KENWOOD

SB-978

SERVICE BULLETIN AMATEUR RADIO

SUBJECT TH-75A INTERMITTENT MEMORY LOSS	DATE 08/08/90
--	------------------

FIGURE 4

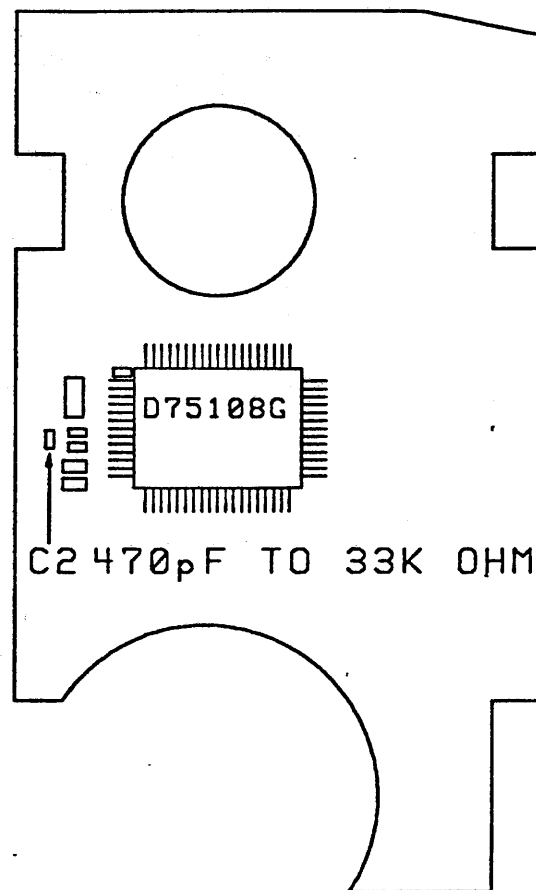
7. Lay the Control board on a soft cloth to avoid scratching the LCD.
8. Locate chip capacitor C2 on the Control board. **Figure 4**
9. Replace C2 with a 33K ohm chip resistor.

FIGURE 5

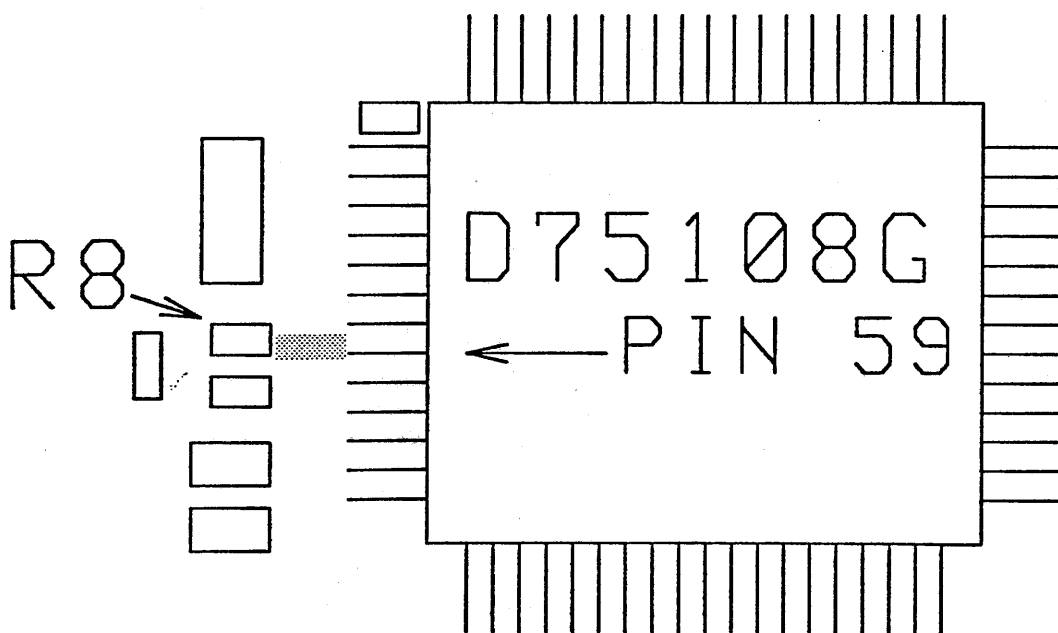
10. Remove the protective coating from the foil between pin 58 of the microprocessor and chip resistor R8. Presolder the exposed foil. **Figure 5**
11. Size, cut, and bend the leads of the 470pF ceramic disc capacitor and then install the component between pin 59 of the microprocessor and the ground side of the 33K ohm chip resistor. **Figure 6**

FIGURE 7

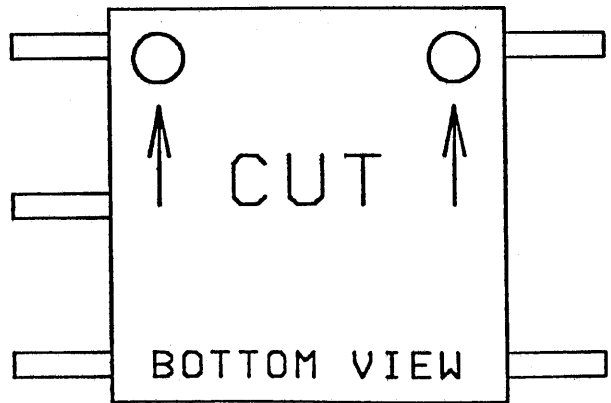
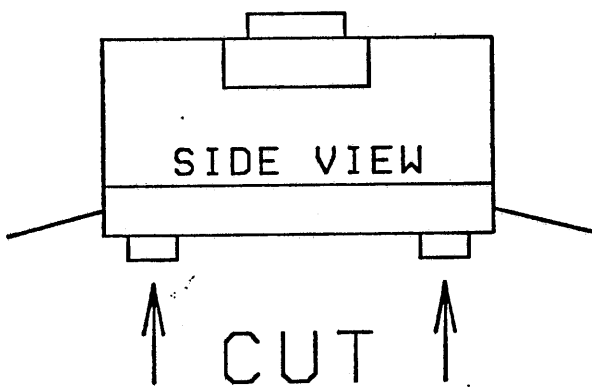
12. Remove the screw from the PTT switch assembly and then remove the rubber PTT cover from the board. Be careful not to lose the black plastic plate that fits inside the rubber cover.
13. Remove the PTT switch from the board.
14. Cut the tabs off the bottom of the new PTT switch to allow the switch to lay flush on the board. Figure 7
15. Install the PTT switch.
16. Assemble the transceiver.
